UNITED STATES PATENT AND TRADEMARK OFFICE

APPLICATION NO.	FILING DATE	FIRST NAMED INVENTOR	ATTORNEY DOCKET NO.	CONFIRMATION NO.
10/574,452	04/04/2006	Peter Flisikowski	NL 031202	9326

Office Action Summary

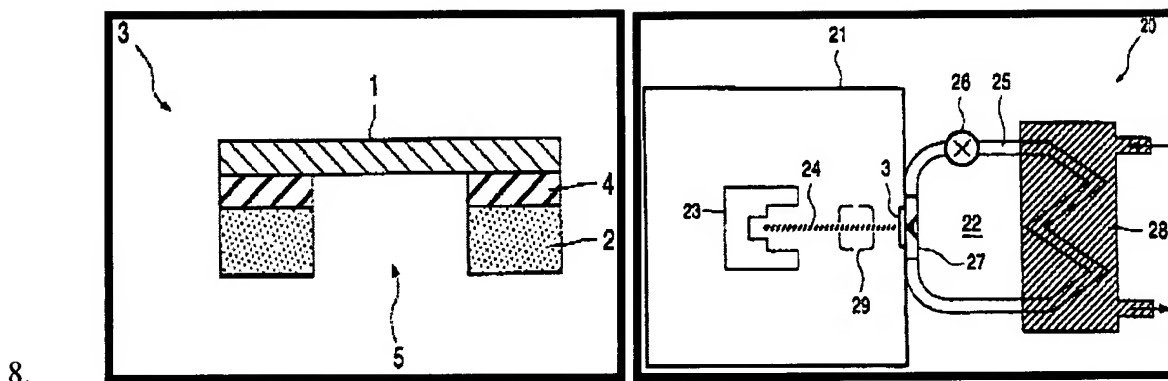
9. As per claims 1, 2 and 10, Bachmann et al. disclose a method of manufacturing a window (3), comprising the steps of: providing on a surface of a carrier element (2) a window foil (1), the surface of the carrier element having a receiving area, receiving a soldering material (4); the soldering material (4) fixing the window foil (1) to the carrier element (2); the carrier element (2) further comprising a through hole (5) for the transmission of electrons; placing the window foil (1) on top of the surface and heating the soldering material (4) to affix the window foil (1) to the surface (see Fig. 1, shown above; see also para. [0013]).

10. As per claims 11-12, Bachmann et al. disclose a window further comprising: an X-ray device (20), having an electron source (23), a target (22) and window (3); the window (3) being located between the electron source (23) and target (22) – (see Fig. 8, shown above; see also para. [0037]).
